SUBJECT: Response to Second Incomplete Notification Letter on March 30, 2020
Notification No. 1600-2019-0068-R4
Lost Lake Nature Trail, San Joaquin River – Fresno County
Transmitted via Email to: R4LSA@wildlife.ca.gov

Subject: Second Incomplete Notification of Lake or Streambed Alteration
Notification No. 1600-2019-0068-R4
Lost Lake Nature Trail
San Joaquin River – Fresno County

Lost Lake Trail Improvement Project
 Fresno County, CA
 (42C0458)

Tree Map

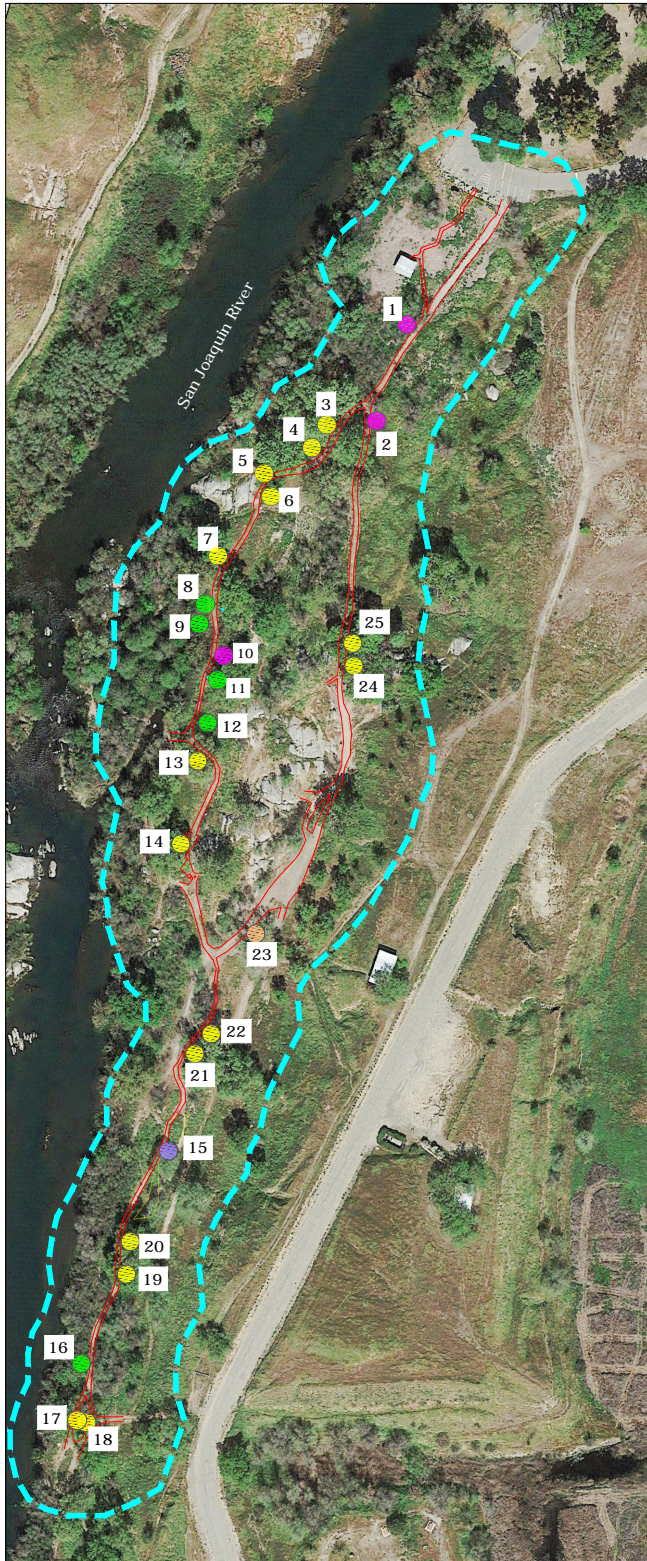
- To address or illustrate the tree trimming that will be required, please provide photos with markup, diagrams, and/or more specific description, of how trees will be cut. This information is necessary for an understanding of how much would be cut from each tree and what the resulting impacts would be.
- The plans are labeled as “100% Submittal: Not for Construction.” Please describe if or how the final plans may vary from the submitted plans.

1. Description of Tree Trimming:
 - a. The trees will be limbed up about 6' to 15' from the ground for pedestrian clearance purposes only – please see Tree Map for approximate percentage trimmed. Branches that are overhanging the trail will be removed to allow for clear access to the trail, but will not be detrimental to the tree. Cut branches and excess debris will be properly cleared and disposed of. Precautions shall be taken to avoid damaging surrounding vegetation, so no other impacts to riparian vegetation will occur.
 - b. See attached Tree Map for tree trimming illustrations.

Note : Trees will be trimmed to provide pedestrian clearance 9' above finished grade
